**Economic Commission for Europe****Inland Transport Committee****World Forum for Harmonization of Vehicle Regulations****Working Party on Noise****Sixty-fourth session**

**Collective amendments****Proposal for Supplement 3 to Regulation No. 9****Submitted by the expert from the European Commission\***

### **"Uniform provisions concerning the approval of category L<sub>2</sub>, L<sub>4</sub> and L<sub>5</sub> vehicles with regard to noise sound emission"**

Table 1  
**Correction applied to individual measured test value**

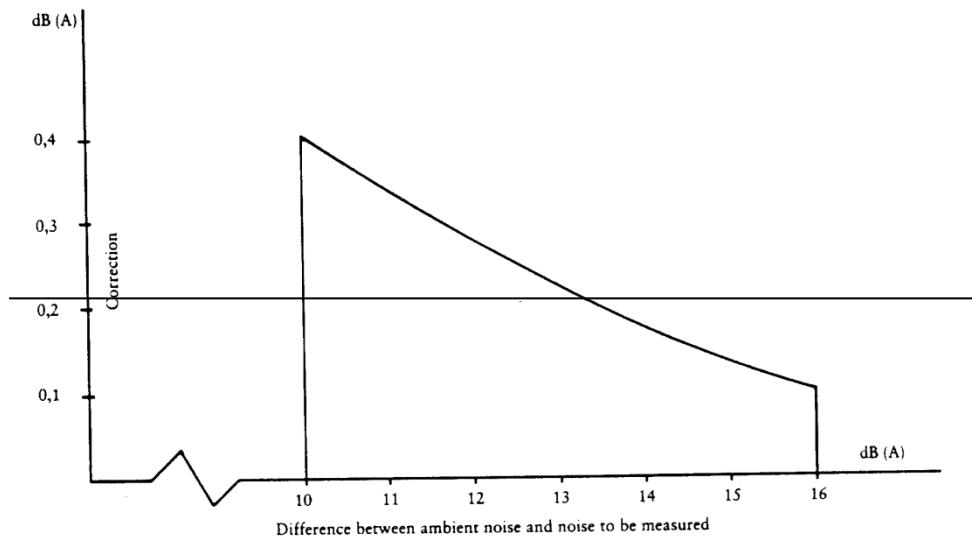
35. In the new sub-paragraph 2.1.2., the figure "Weather conditions and background noise correction" was deleted, because it was not in line with the table, which contained the correct values.

Figure 1: Measuring positions for vehicles in motion

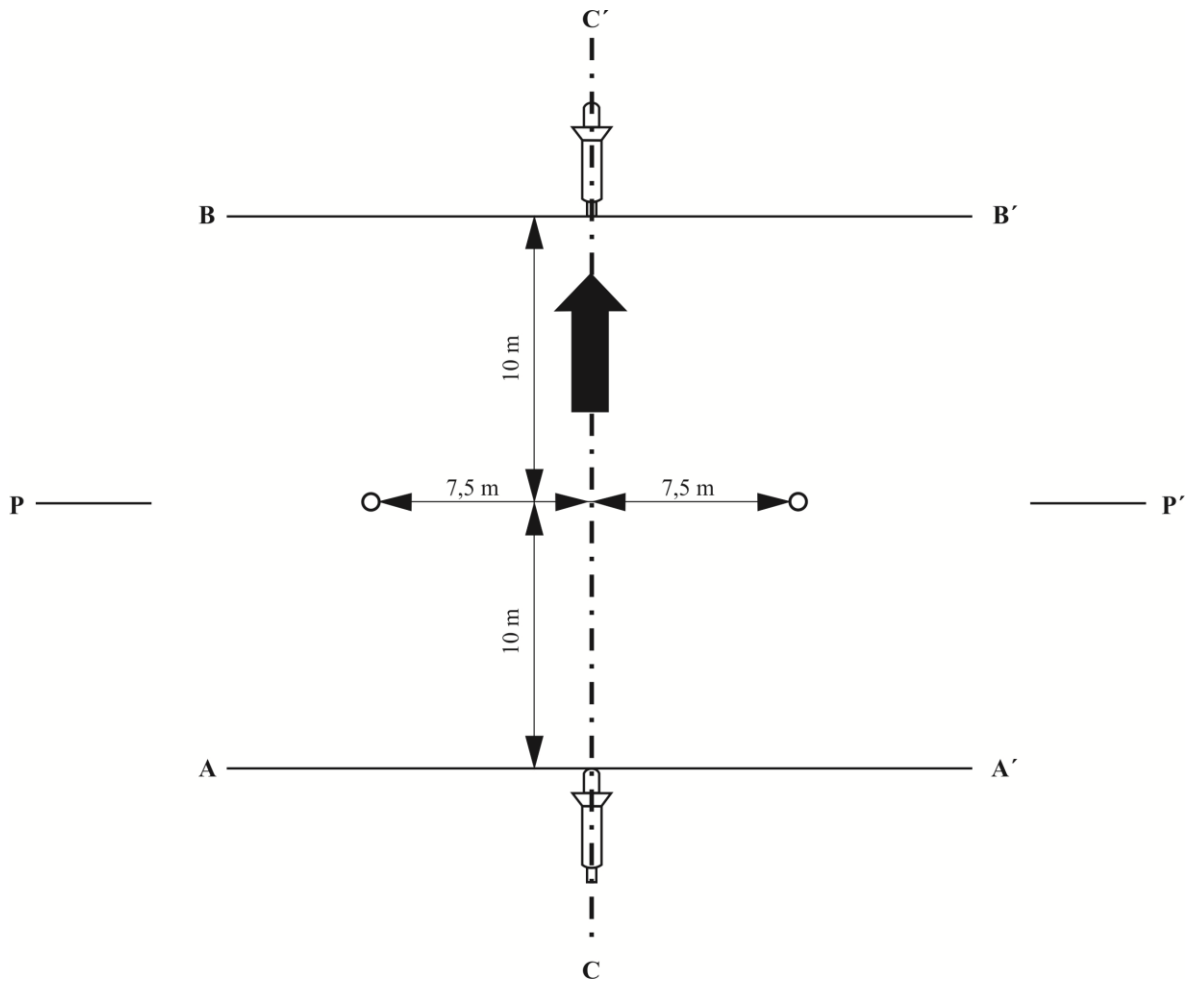
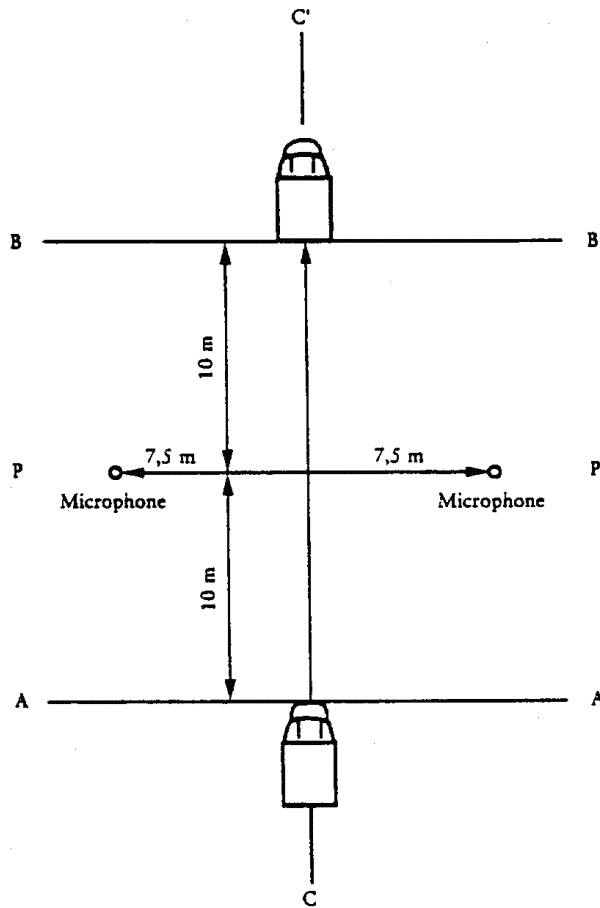
3.1.1.1. **The test arrangement is shown in figure 1.**

3.1.1.2. **The distance of the microphone positions from the line CC', on the microphone line PP', perpendicular to the reference line CC' on the test track (see Figure 1), shall be  $7.5 \pm 0.05$  m.**

38. Header 3.1.1. "Positions for the test" was replaced by "Test arrangement and microphone positions". Figure 1 was moved from the current position to this paragraph.

Figure 2: Microphone positions for the measurement of sound of the stationary vehicle

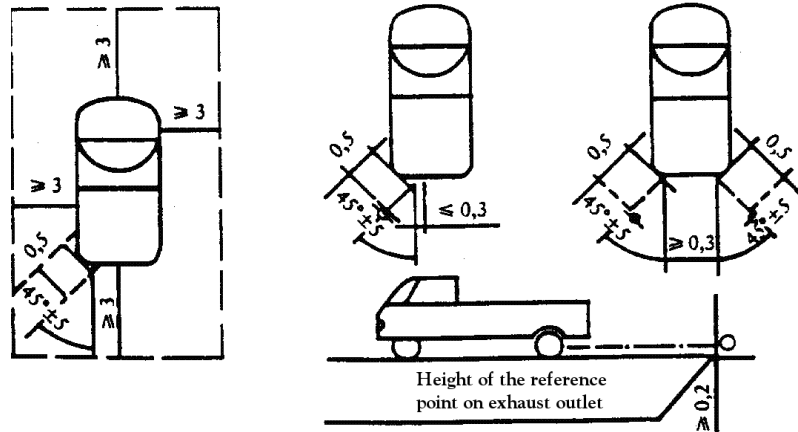
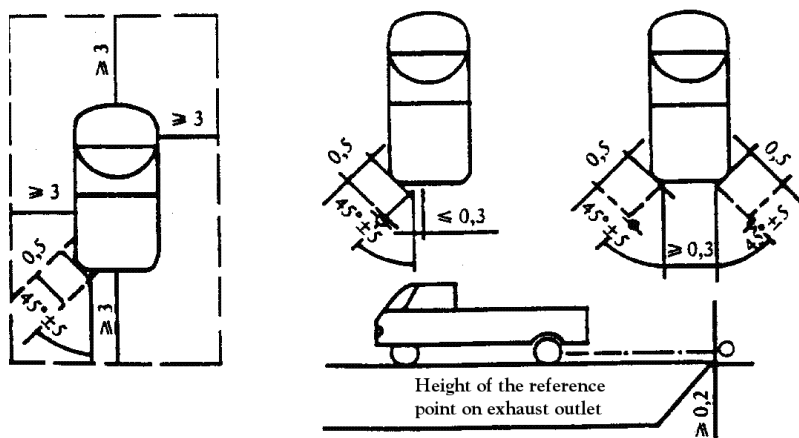
3.2.4.2. Positioning of the microphone (see Figure 2 ~~of Appendix to this annex~~)

45. Figures 2 and 4 were moved from the current positions (in the appendix) to this paragraph, because they belong to it. Figure 4 was renamed to figure 3 in order to ensure the right order.

Figure 4. Test apparatus for conditioning by pulsation

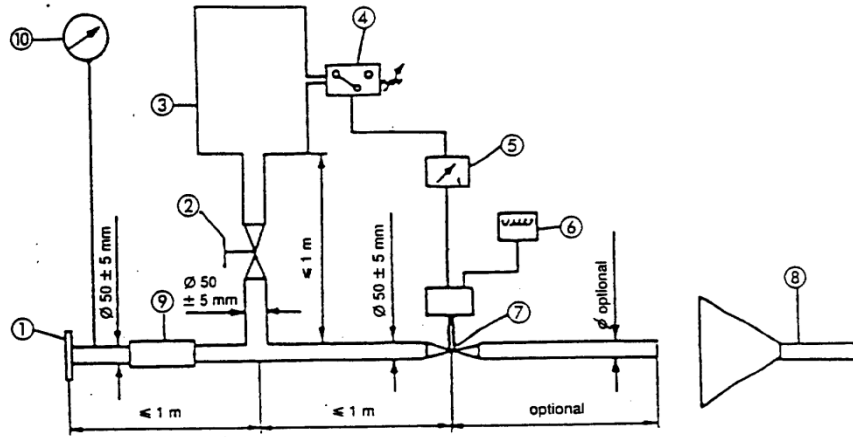
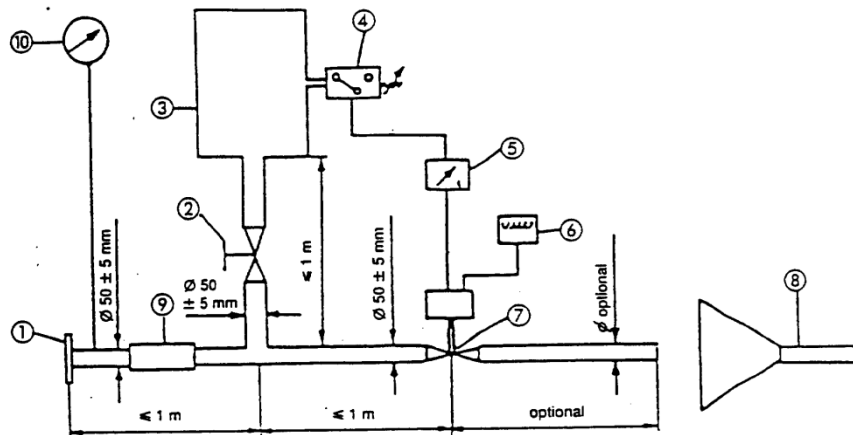
The test apparatus, a detailed diagram of which is shown in Figure 3 4 of Appendix to this annex, shall be fitted at the outlet of the exhaust system. Any other apparatus providing equivalent results shall be acceptable.

50. Figure 3 was moved from paragraph 5.3. to this paragraph, where it belongs to, and was renamed to figure 4 to keep the right order.
